ADDENDUM NUMBER ONE

Bids Received until
2:00 P.M. CDT November 17, 2011
Hoover City Schools Board of Education
2810 Metropolitan Way
Hoover, Alabama 35243

Harold L. Foshee Architects
345 Highgate Hill
Indian Springs,
Alabama 35124

**ADDITIONS TO
HOOVER HIGH SCHOOL
HOOVER, ALABAMA**

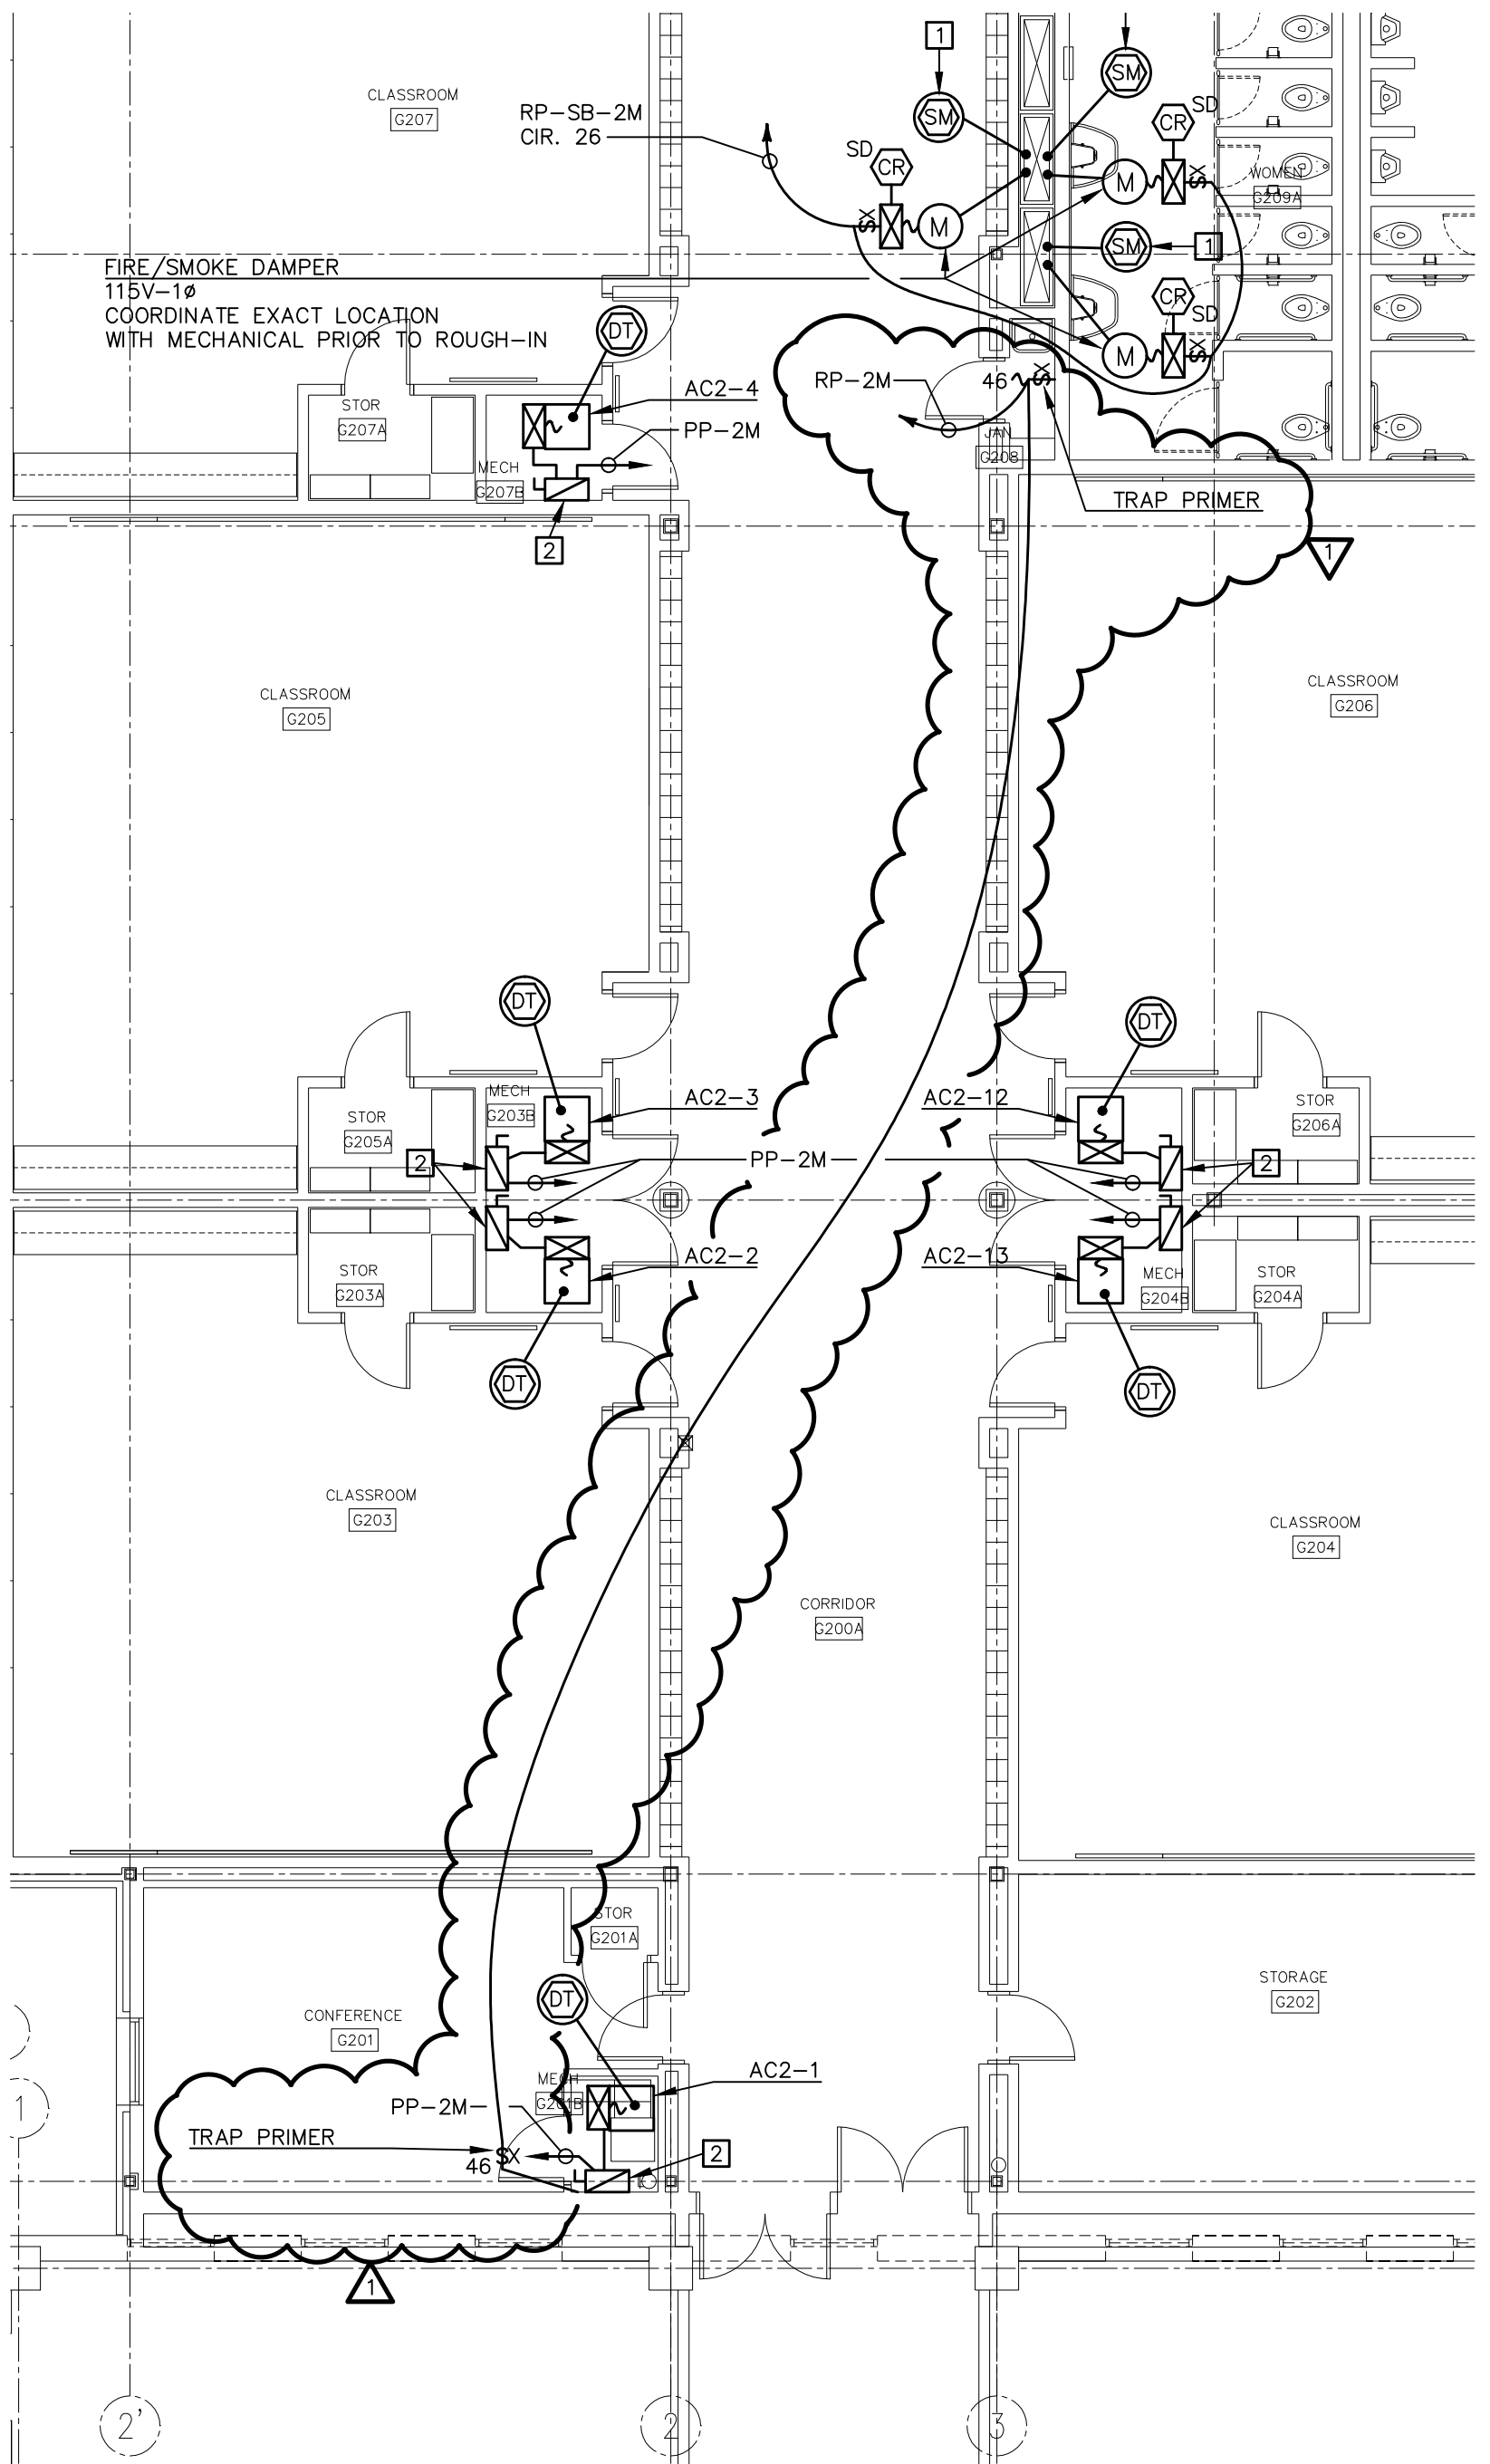
D1.31 Sheet No. E4.4:

A. Revise as shown on attachment SD-E11.

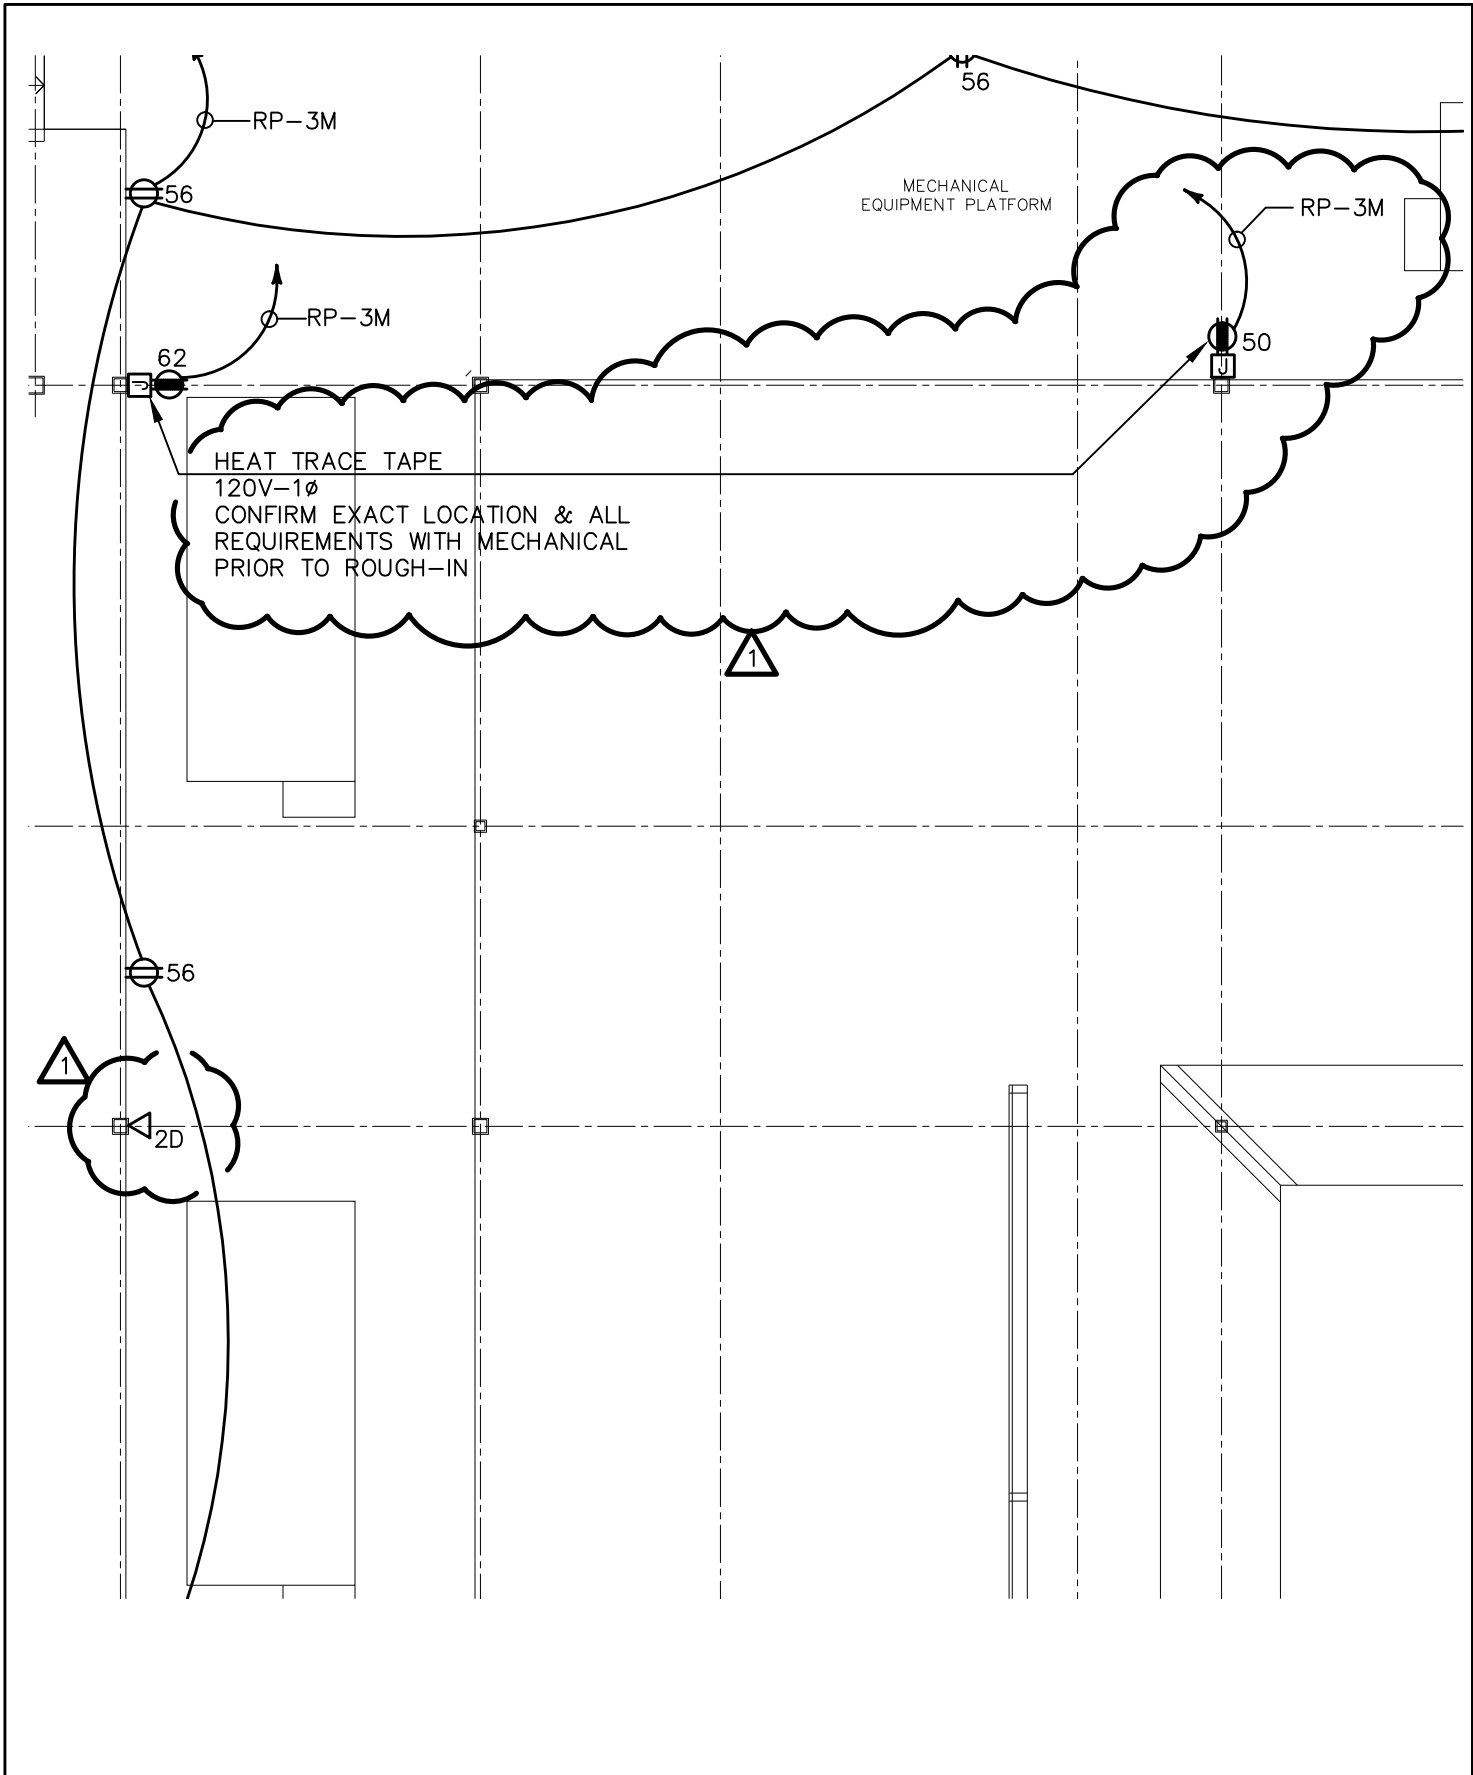
D1.30 Sheet No. E4.2:

A. Revise as shown on attachment SD-E12.
